Access Compliance Report

Public Rights-of-Way

(Curb Ramps)

Intersection ID: 30115	Main Street: SETHS_DR	Cross Street: W_SUGAR_CREEK_RD	Location: W
ADA ID: BADC56E1A60A	Ramp Type: Perp	Initial Pass/Fail: Pass	Overall Compliance: No
Severity Score: 15			
Codes/Mitigation Info/Possible Solution		Field Measurements/Component Compliance

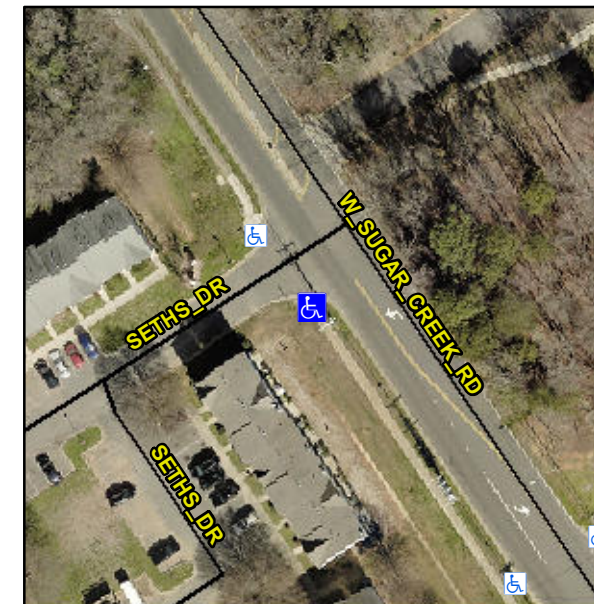
**Not Found, R304.2.2-Perp, R304.3.2-
Para, R304.5.3, R305.2, R302.7.2**

Compliance	Description	Data	Compliance	Description	Data
N/A	Ramp Length (in)	70.0	Yes	Ramp Slope (%)	7.0
Yes	Ramp Width (in)	49.0	Yes	Ramp XSlope (%)	1.5
N/A	Flare Type LT	Sloped	N/A	Flare Type RT	N/A
N/A	Flare Slope LT (%)	3.1	N/A	Flare Slope RT (%)	8.0
N/A	Flare Traversable LT?	No	N/A	Flare Traversable RT?	No
Yes	Landing Length (in)	62.0	Yes	DWS Provided?	Yes
Yes	Landing Width (in)	59.0	Yes	DWS Contrast?	Yes
No	Landing Slope (%)	2.9	Yes	DWS Length (in)	25.0
No	Landing X Slope (%)	2.2	Yes	DWS Full Width?	Yes
N/A	Landing Curb? (Y/N)	No	No	DWS Offset (in)	3.5
N/A	Shared Landing?	No			
Yes	Gutter Ponding?	No	Yes	Gutter Slope (%)	4.0
No	Gutter Lip Ht (in)	1.0	No	Gutter X Slope (%)	2.8
N/A	Painted X Walk1?	No	N/A	Painted X Walk2?	N/A
	X Walk 1 Direction	To N		X Walk 2 Direction	N/A
N/A	X Walk 1 Width (in)	N/A	N/A	X Walk 2 Width (in)	N/A
	X Walk 1 Slope (%)	2.7		X Walk 2 Slope (%)	N/A
	X Walk 1 X Slope (%)	3.7		X Walk 2 X Slope (%)	N/A

N/A	Ramp inside XWalk1?	N/A	N/A	Ramp inside XWalk2?	N/A
	Road Slope (%)	N/A	N/A	Clear Space?	Yes
	Road X Slope (%)	N/A	N/A	Clear Space to XWalk (in)	N/A
Yes	Any Obstructions?	No	Yes	Storm Grate/Utility Hazard?	No
	Obstruction Type			Storm Grate/Utility Type	
		N/A			N/A
			Yes	Surface Condition? (G/P)	Good

**Remove & Replace Entire Ramp.
Remove & Replace Gutter.**
